McLaren Senna Rear Lower Wishbone Replacement

Bulletin type: Service Campaign
Reference number: 15 B 001
Campaign reference: 040
Attention: Retailer Service Managers and Retailer Technicians.
Affected vehicles: McLaren Senna
Situation: Rear lower wishbone bushes degradation
Procedure: Please refer to the information outlined in this document to replace both rear lower wishbones with 720S parts and replace fixing bolts
Date: 21st February 2019

McLaren Senna Rear Lower Wishbone

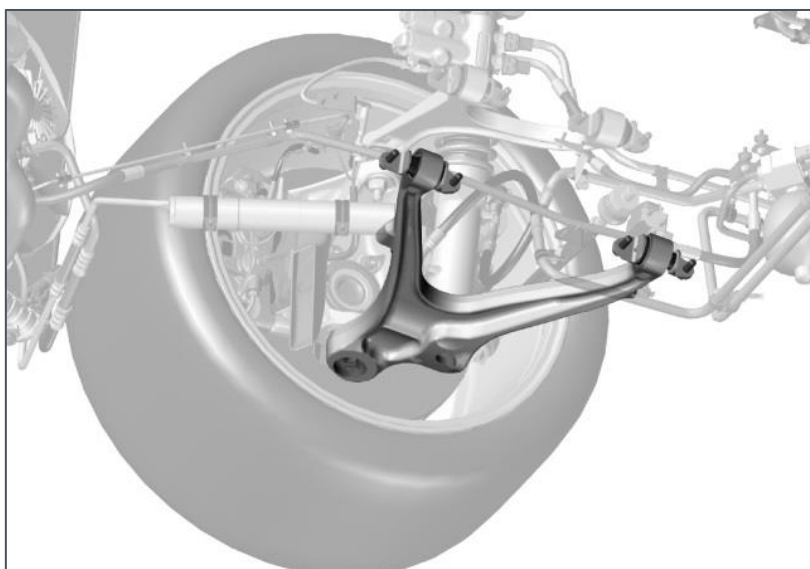
McLaren Automotive, through the development process, has identified that the rear suspension lower wishbone bushes may experience an unacceptable level of degradation after long term use. This can affect the vehicle's handling and/or cause knocking noises. Due to this, we recommend that the rear lower wishbone is replaced at the next visit to the Retailer or upon customer concern as detailed below.

To eliminate this condition, the recommended action is to replace both rear lower wishbones with the updated parts indicated in the table below, including the fixing bolts.

Care Point: New fixing bolts must be used when installing the new wishbones.
